CAROL PLANTATION SUBDIVISION,
THIRD UNIT, RESUBDIVISION OF A PORTION
OF FARM LOT 520

Revised for the July 5, 2007, Meeting

APPLICATION NUMBER 8 DATE July 5, 2007

DETAIL SITE PLAN

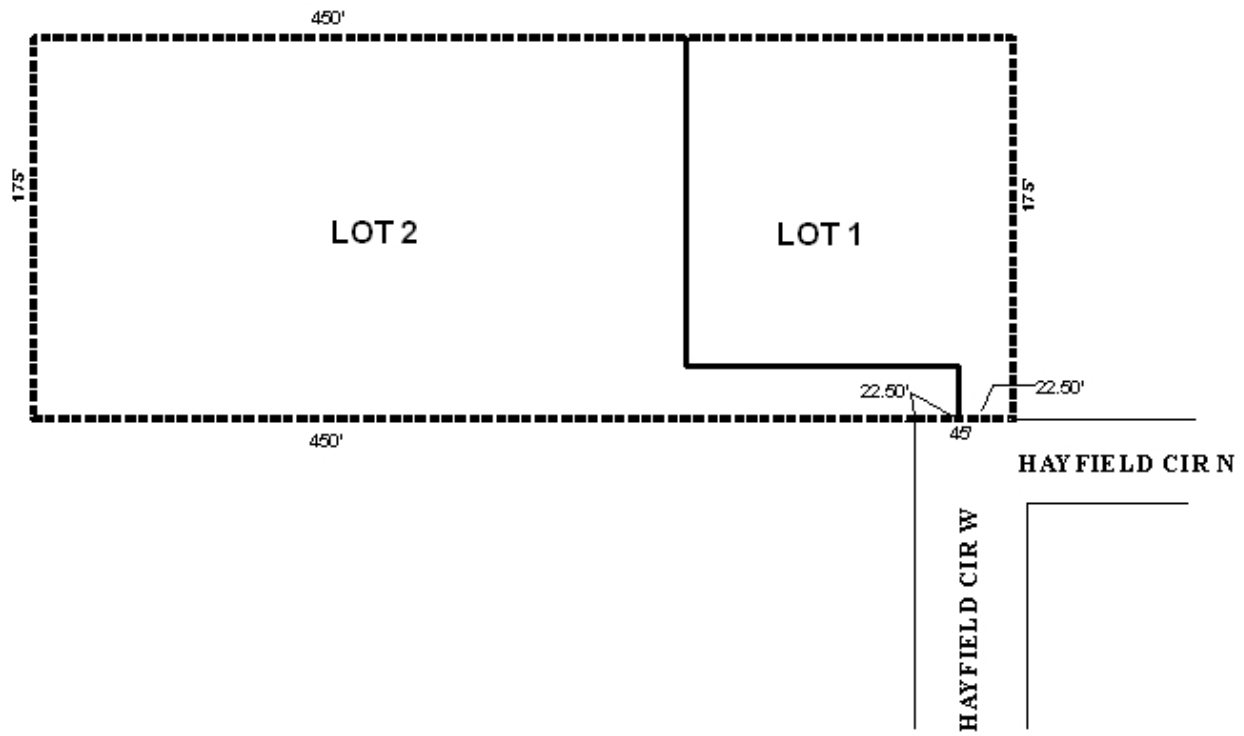
Lastly, the plat seemingly indicates a proposed third lot, but it is not labeled on the plat as such. This is likely a drafting error, as this lot would deny Lot 1 access to a public right-of-way altogether and the lot would not meet the minimum size requirements according to section V.D.2 of the Subdivision Regulations.

At the June 21, 2007, Meeting, the applicant submitted a revised plat for the proposed subdivision. The proposed subdivision no longer includes the previously proposed dedication along the junction of Hayfield Circle North and Hayfield Circle West. The “mystery” line in the proposed Lot 1 was also removed.

The proposed subdivision now features two lots, both flag lots, with 22.5-feet of road frontage, which is less than the required 25-foot minimum for flag lots. Also, as stated previously, the presence of a flag-lot in this neighborhood seems to be out of character as there are no other flag lots in the area. However, given the substantial size of the lot, the real issue here is a matter of road frontage. The road frontage for each proposed lot is deficient by only 2.5 feet. Because of this, a waiver of Section V.D.2 would not be ideal, but could be considered appropriate, with a stipulation that there be a note placed on the final plat denying any future subdivision of this property until additional public right-of-way frontage is acquired. Further, due to the lack of adequate space for a curb cut for each lot, a note should be required on the final plat requiring both sites to share a single curb cut.

The plat should show the size, in square feet, of each lot, or a table with the same information should be provided.

- 1) depiction of the 25-foot minimum building setback line for all lots where they are 60' in width;*
- 2) provision of a note on the final plat stating that Lot 1 and Lot 2 are limited to a single shared curb cut, with the size, design, and location to be approved by the Mobile County Engineering Department;*

- 3) provision of a note on the final plat stating that no further subdivision of this property is to be allowed without acquisition of additional public right-of-way frontage;*

- 6) labeling of each lot in square feet, or provision of a table with the same information.*
